RHODE ISLAND CONTRACT NO.2020-CT-030

HSIP - Crosswalk & Signal Improvements 2020

NOTICE TO PROSPECTIVE BIDDERS

ADDENDUM NO. 3 Prospective bidders and all concerned are hereby notified of the following changes in the Plans, Specifications, Proposal and Distribution of Quantities for this contract. These changes shall be incorporated in the Plans, Specifications, Proposal and Distribution of Quantities, and shall become an integral part of the Contract Documents.

TRAFFIC CONTROL PLAN FOR WORK AT INTERSECTION OF MEMORIAL BLVD/CHAPEL ST - PHASE 1

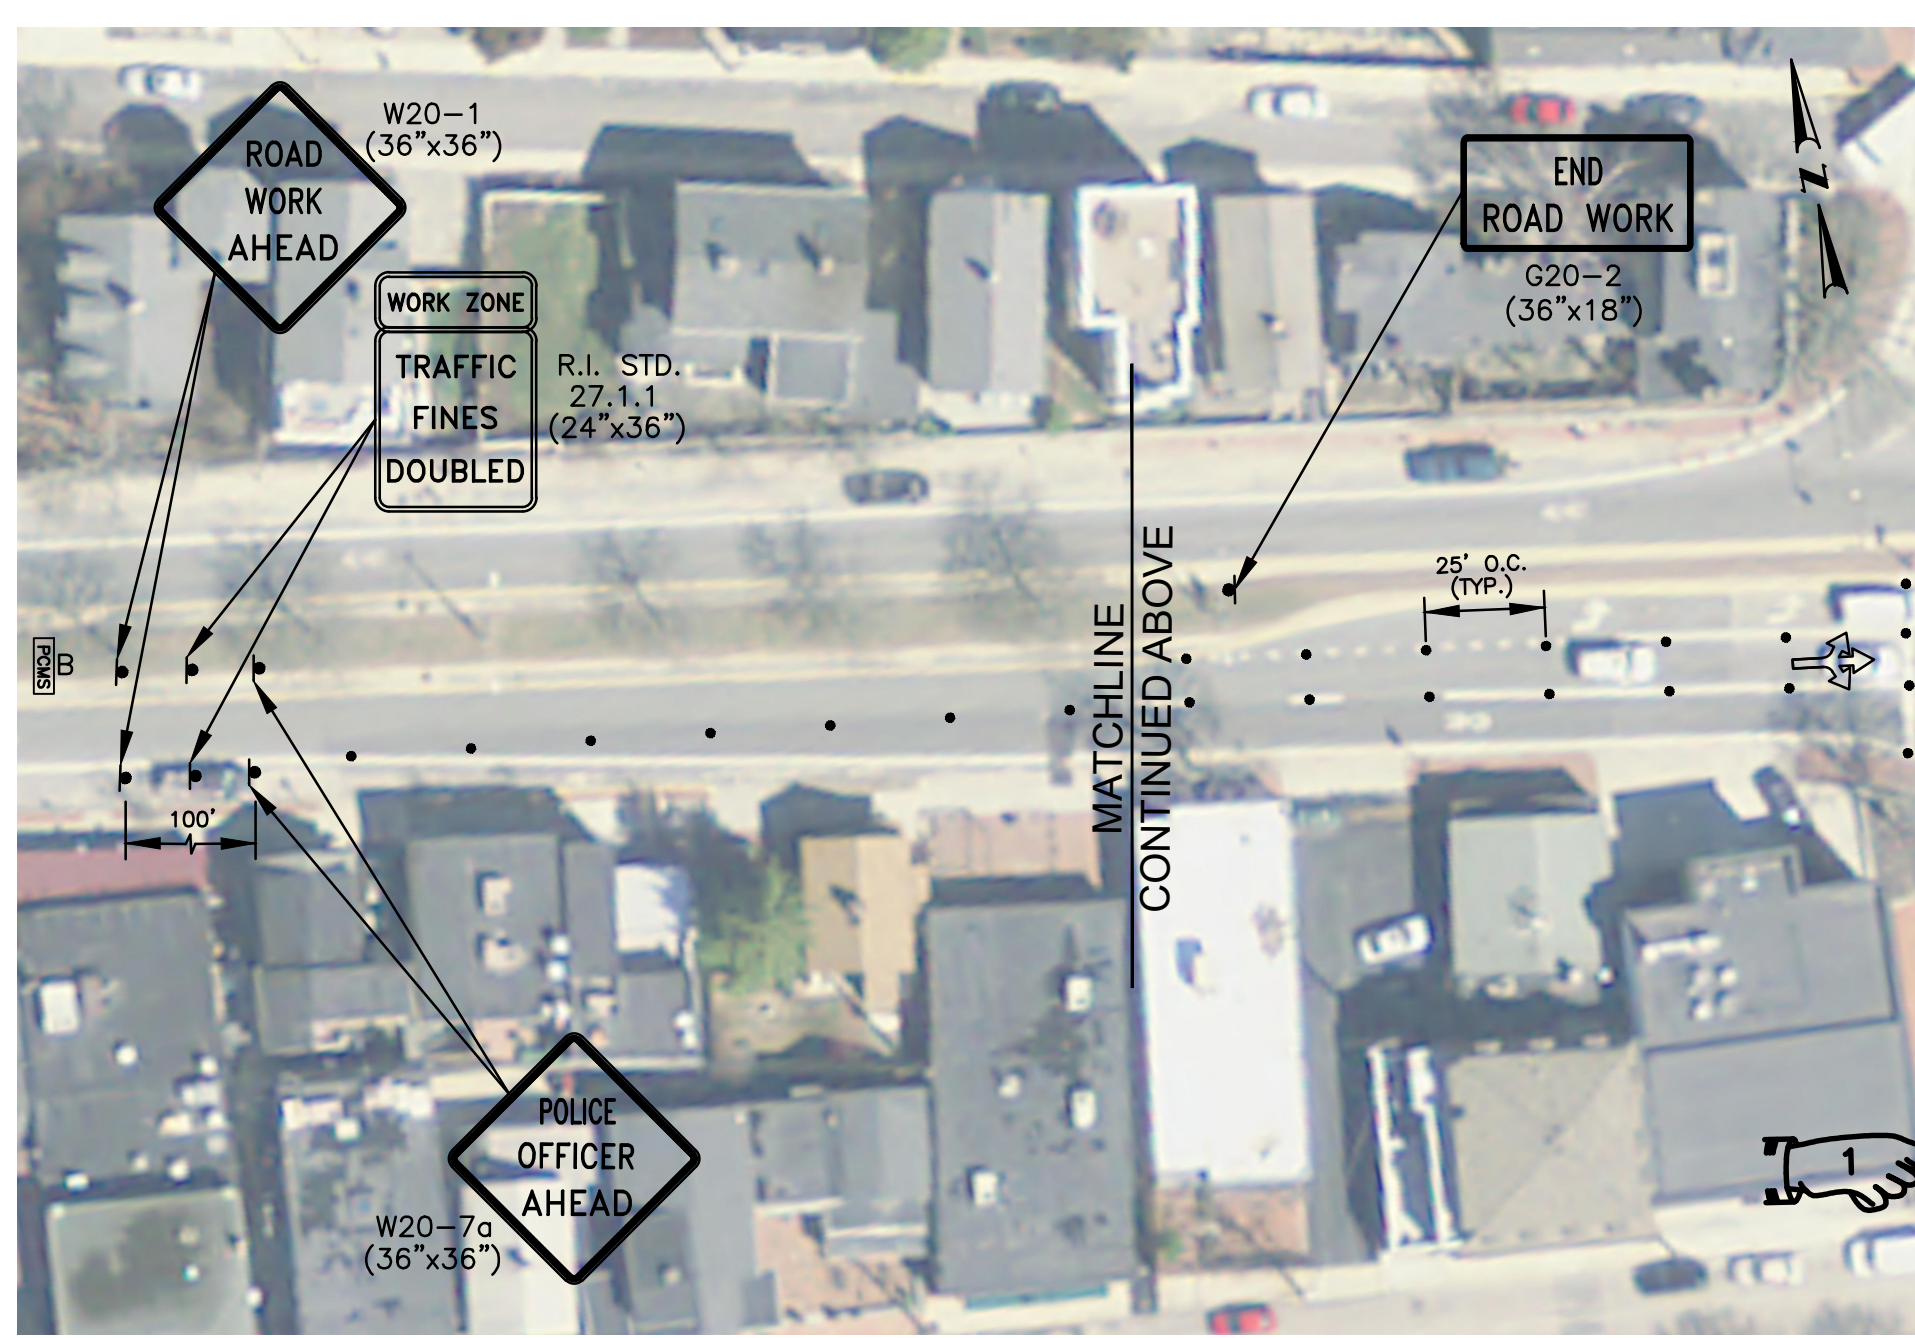
1. Sheet 31, Temporary Traffic Control Plans: Memorial Blvd Crossover at Chapel St - Phase 1

Delete Sheet No. 31 in its entirety and replace it with Sheet No. 31 (R-1) attached to this Addendum. General Notes have been revised.
